# Technical Support Document:

## Chapter 24

### Intended Round 3 Area Designations for the 2010 1-Hour SO<sub>2</sub> Primary National Ambient Air Quality Standard for the Navajo Nation

**Figure 3: Area of Analysis for the Navajo Nation Portion of San Juan County**

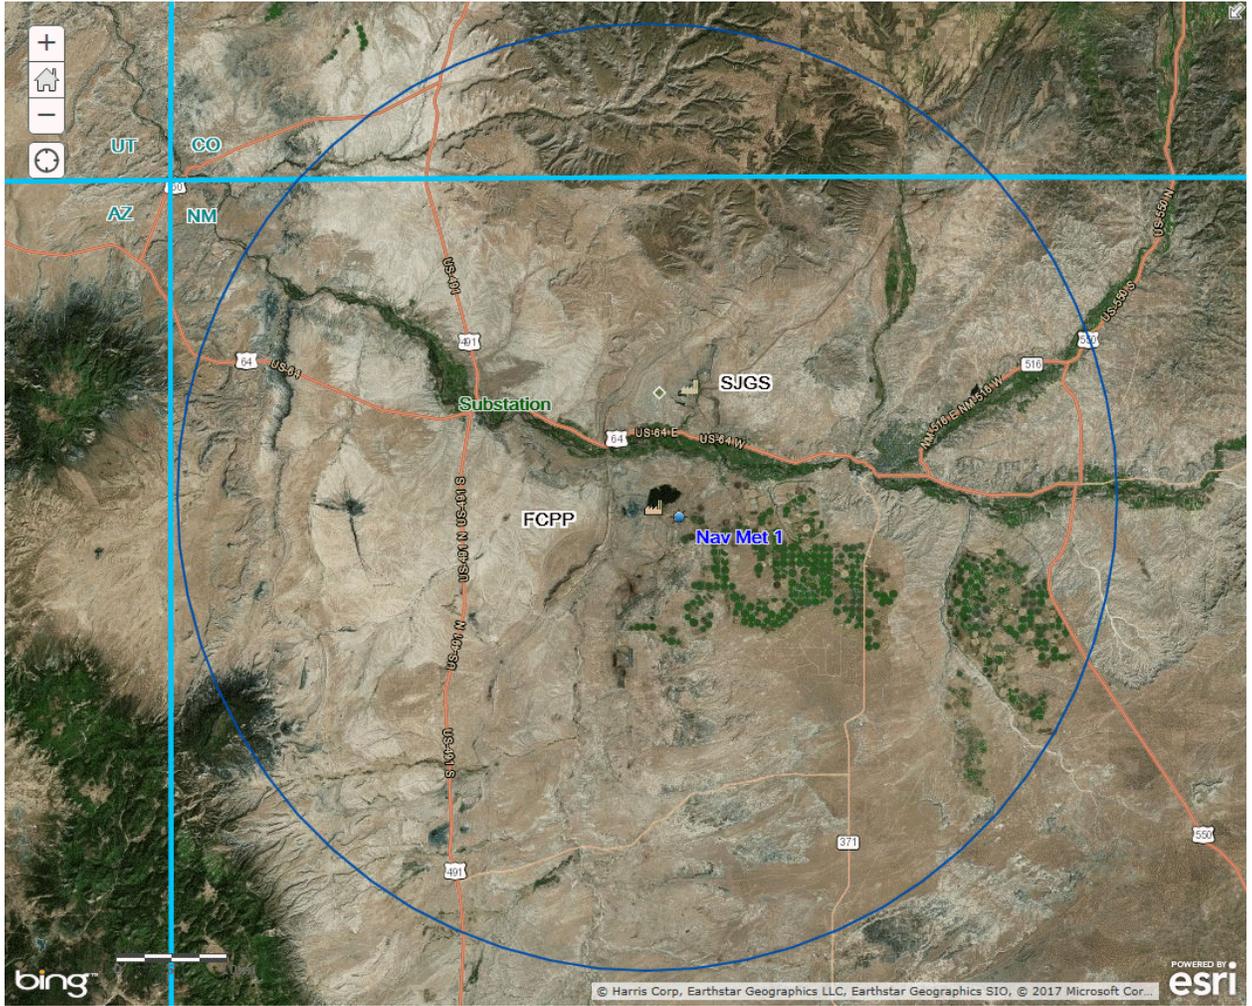
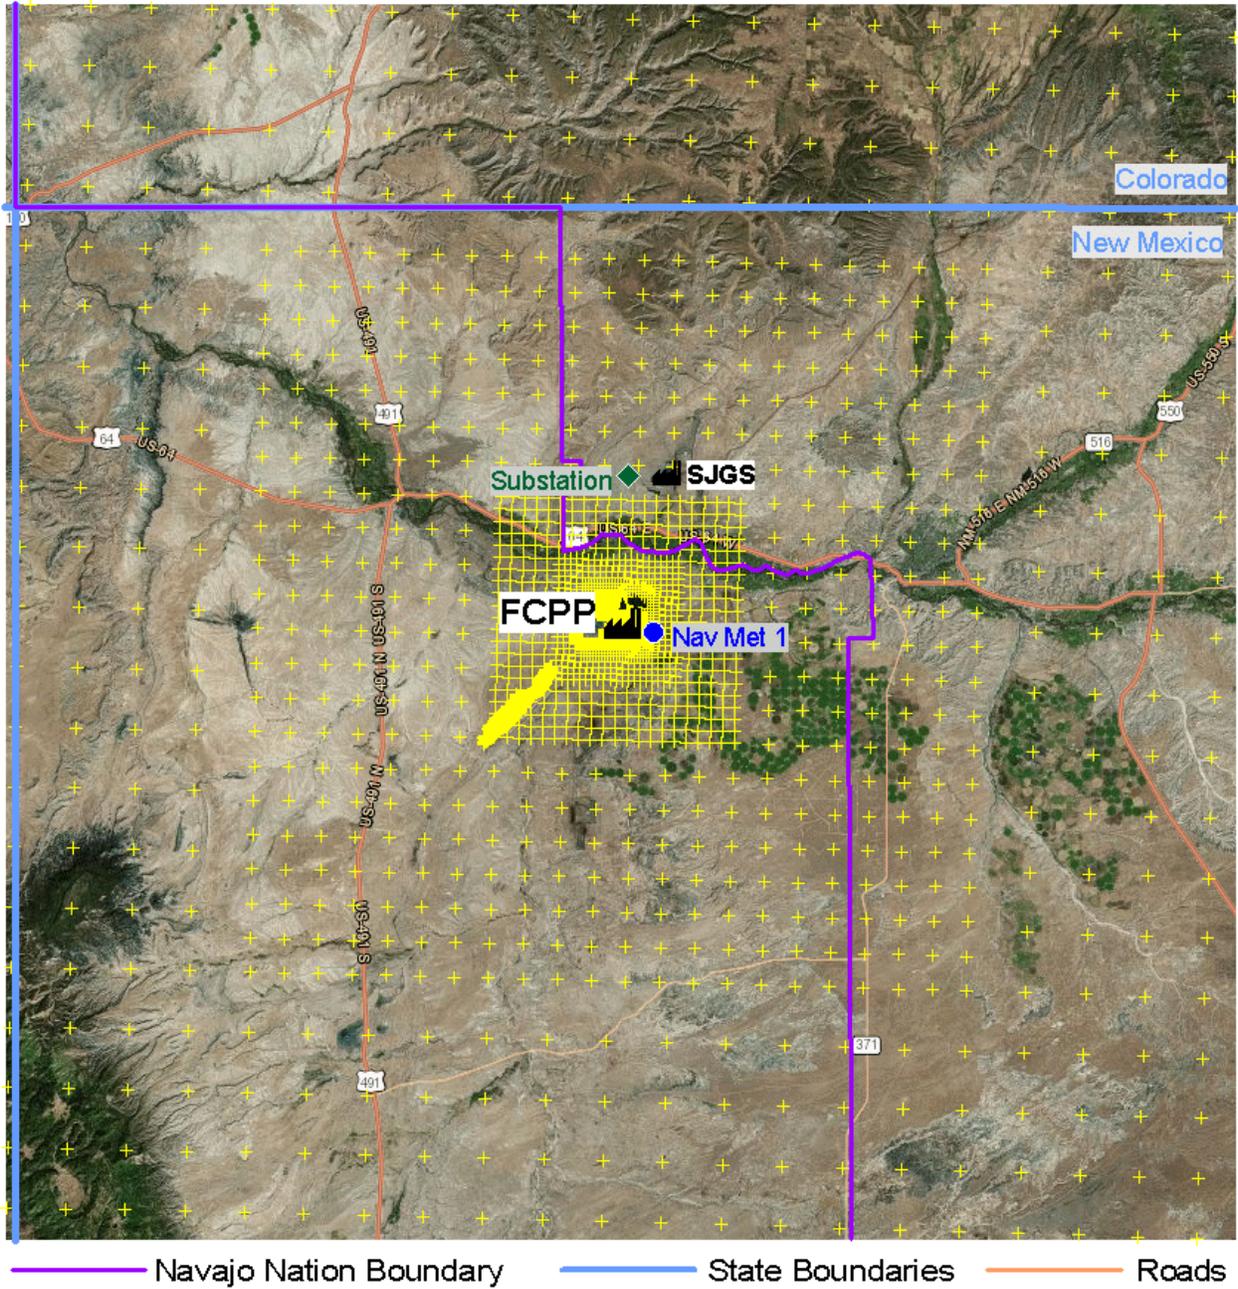
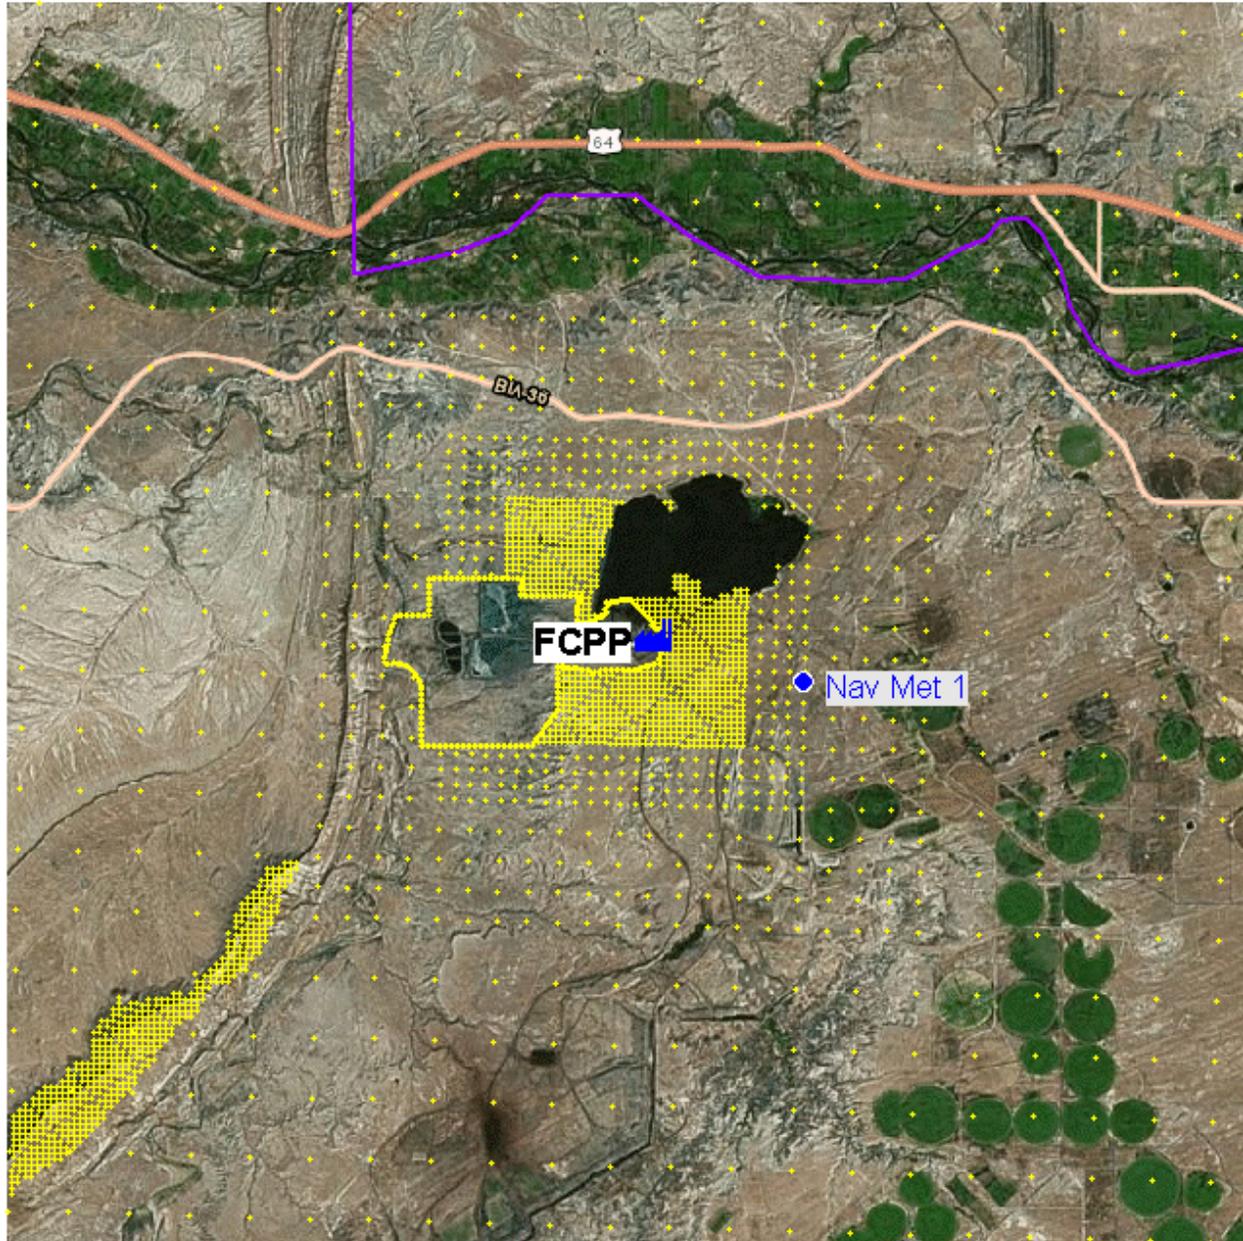
Consistent with the Modeling TAD, the Navajo Nation placed receptors for the purposes of this designation effort in locations that would be considered ambient air relative to each modeled facility, including other facilities' property with the exceptions of locations described in Section 4.2 of the Modeling TAD as not being feasible locations for placing a monitor. Receptors were not placed over the area of Morgan Lake, which is just north of FCPP and provides it with cooling water. While this was not explained explicitly, presumably this was because it would be infeasible to place monitors on the lake. Monitors were also not included within the fence line of FCPP; as such locations would not be considered to be ambient air relative to FCPP if shown that public access is precluded. Although no additional information was provided relating to the preclusion of public access by the fence, fences are visible in satellite photographs of the area, and correspond to the interior gap of receptors in Figure 5.

The EPA finds that the placement of model receptors was adequate to assess maximum SO<sub>2</sub> concentrations, and that receptors excluded from the modeling were appropriate to exclude.

**Figure 6: Navajo Nation Portion of San Juan County Cumulative Annual Wind Rose for Years 2012 – 2014**

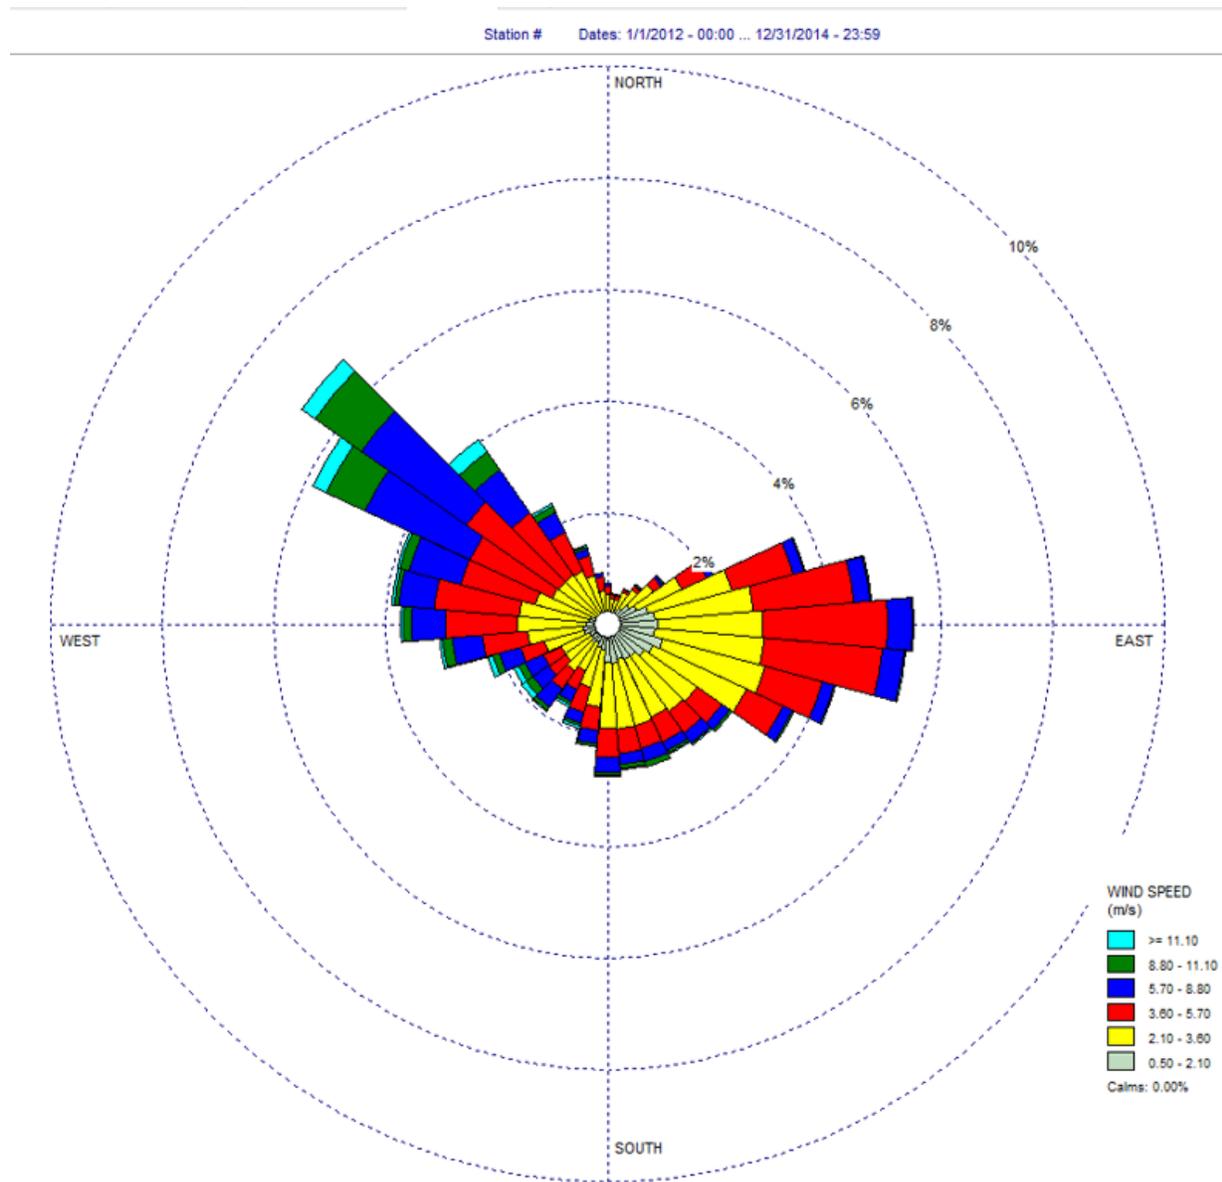
As part of its analysis, the Navajo Nation provided the 3-year surface wind rose for the Navajo Met 1 station. In Figure 6, the frequency and magnitude of wind speed and direction are defined in terms of from where the wind is blowing. Wind most often comes from the northwest, with east winds also common, and some south. Only rarely does wind come from the north.

The EPA finds that the meteorological data inputs for AERMOD were prepared in an adequate way, in accordance with EPA-recommended procedures.

**Figure 7: Maximum Predicted 99<sup>th</sup> Percentile Daily Maximum 1-Hour  $\text{SO}_2$  Concentrations Averaged Over 3 Years for the Area of Analysis for the Navajo Nation Portion of San Juan County**

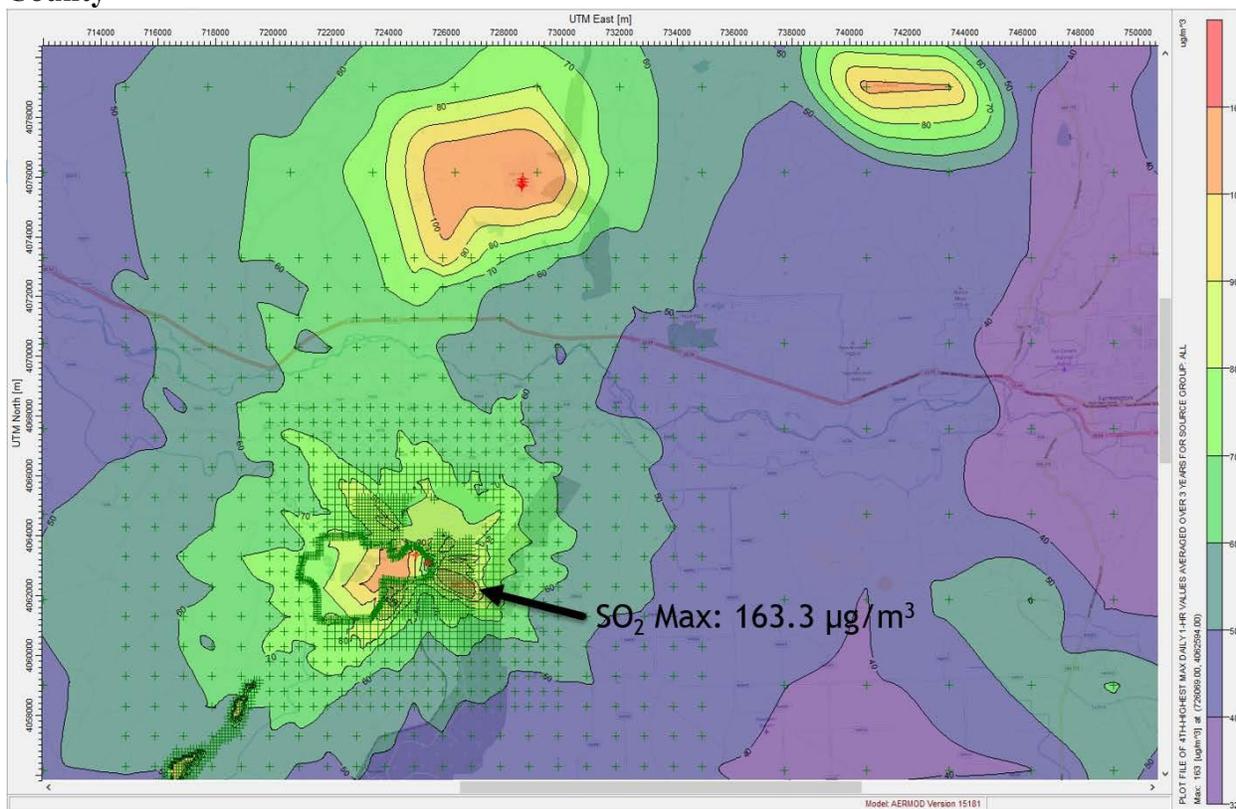
The Navajo Nation’s modeling indicates that the highest predicted 99<sup>th</sup> percentile daily maximum 1-hour concentration within the chosen modeling domain is 163.1  $\mu\text{g}/\text{m}^3$ , equivalent to 62.3 ppb. When SJGS is included, the corresponding maximum is 163.3  $\mu\text{g}/\text{m}^3$ , equivalent to 62.4 ppb. This modeled concentration included the background concentration of  $\text{SO}_2$ , and is based on actual emissions from the facility. Figure 7 below was included as part of the Navajo Nation’s analysis, and indicates that the predicted value occurred less than 1 km from FCPP, toward the southeast. The Navajo Nation’s receptor grid is also shown in the figure.

The modeling submitted by the Navajo Nation indicates that the 1-hour  $\text{SO}_2$  NAAQS is not violated at the receptor with the highest modeled concentration.

**Figure 11: Area of Analysis and Receptor Grid for the Navajo Nation Portion of Coconino County**

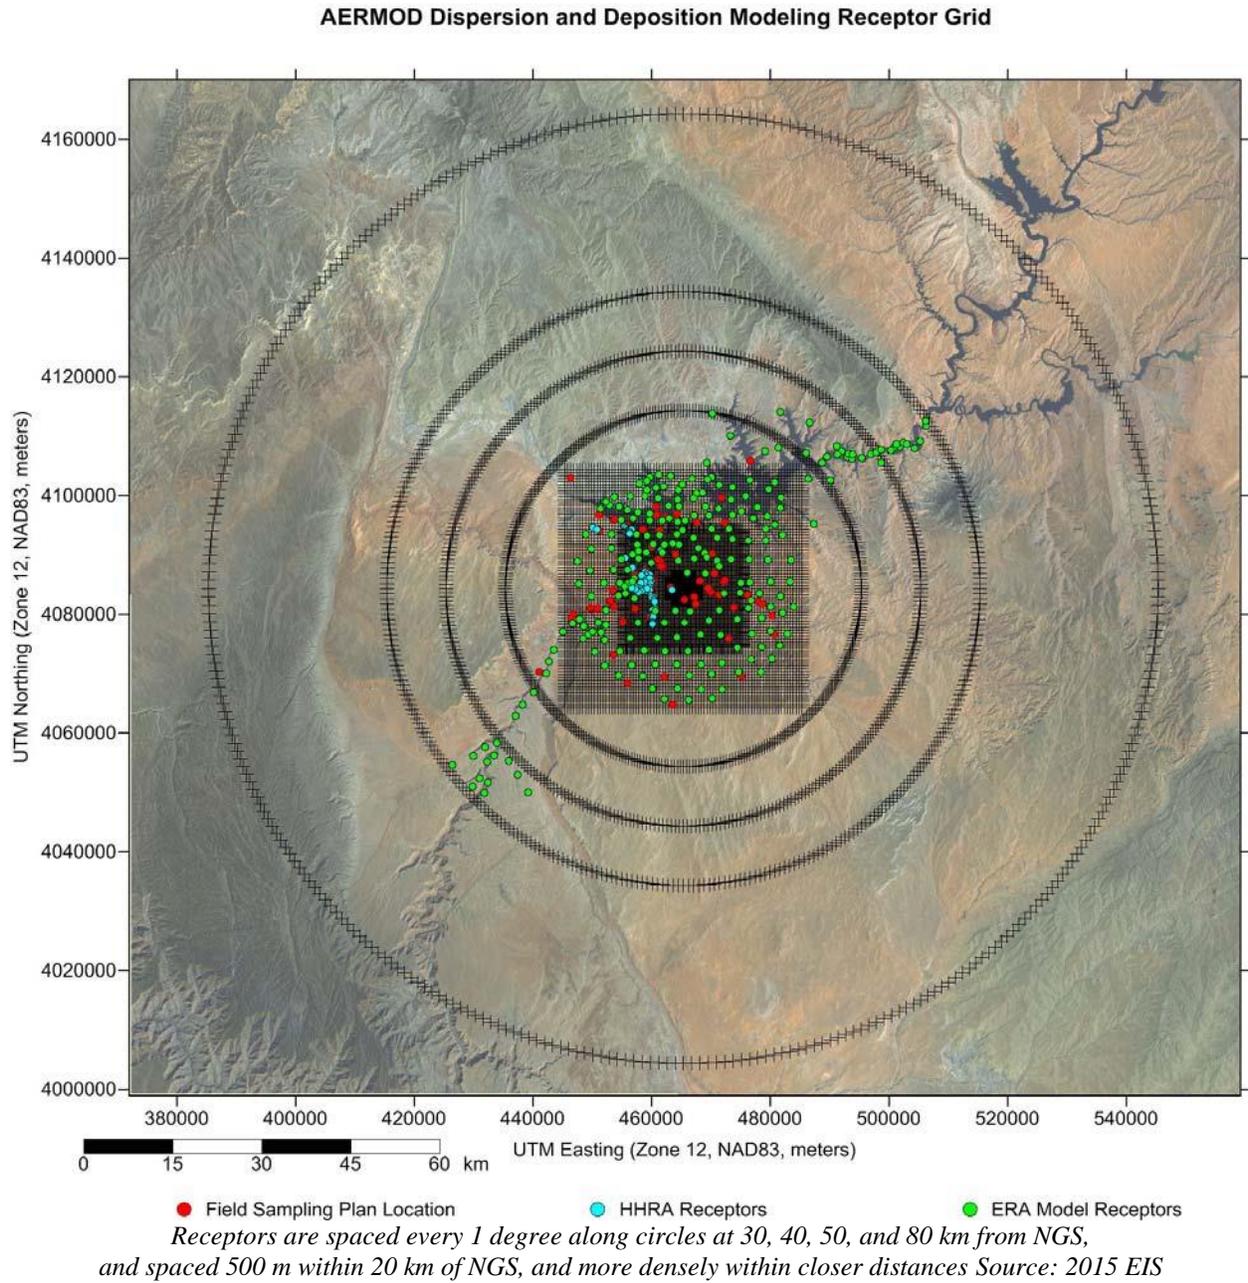
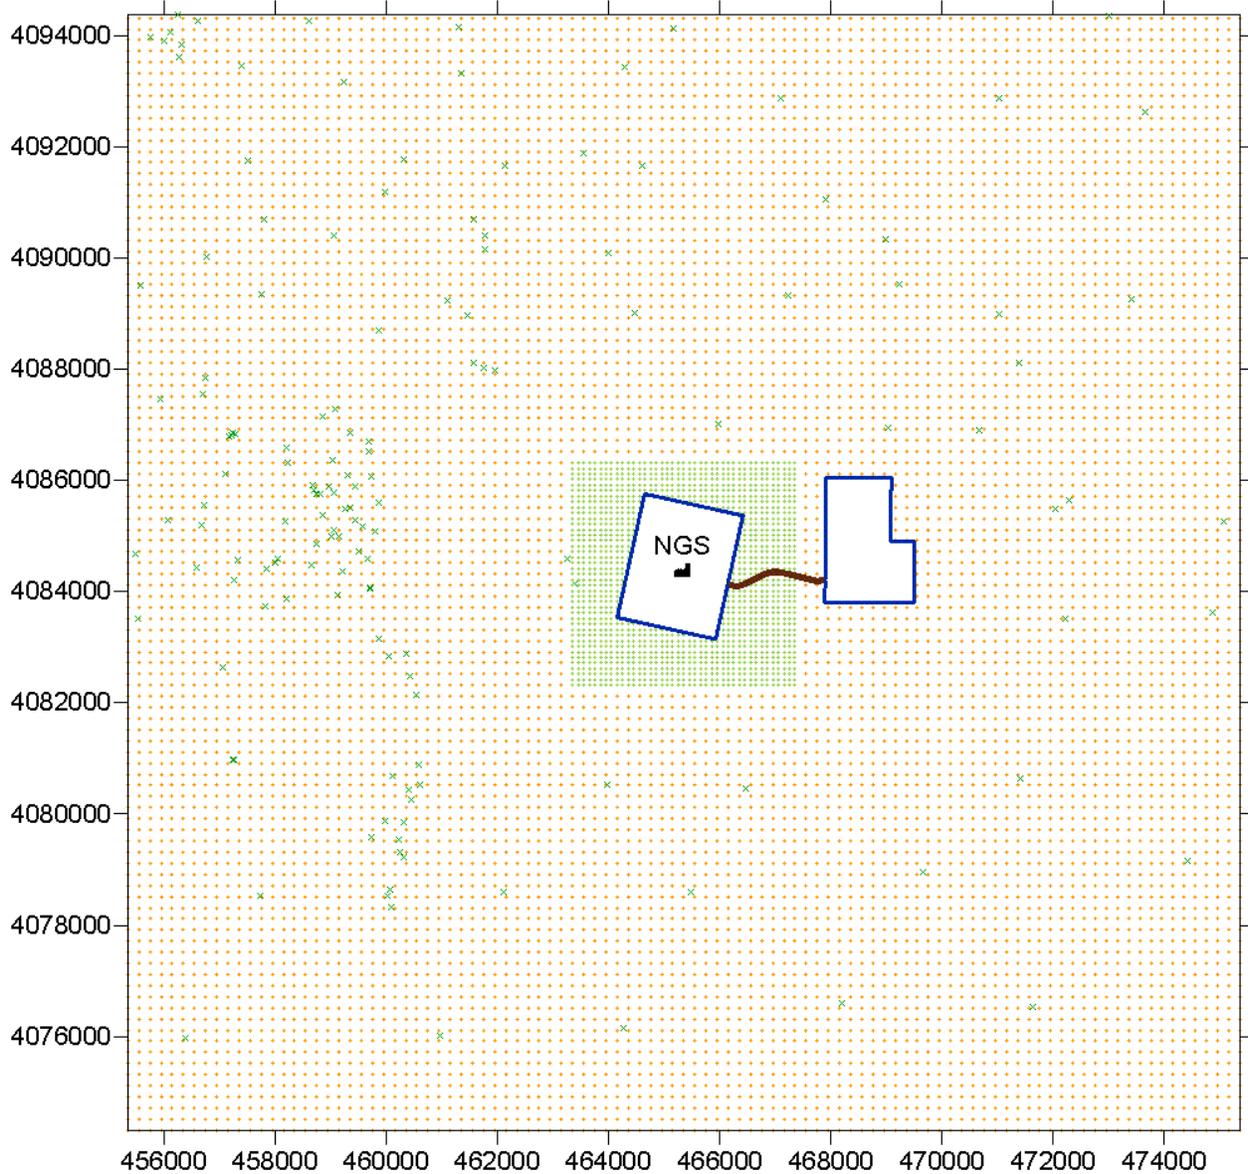
Figures 11 and 12, one from the EIS and one generated by the EPA, show the Navajo Nation's chosen area of analysis surrounding NGS, as well as the receptor grid for the area of analysis.
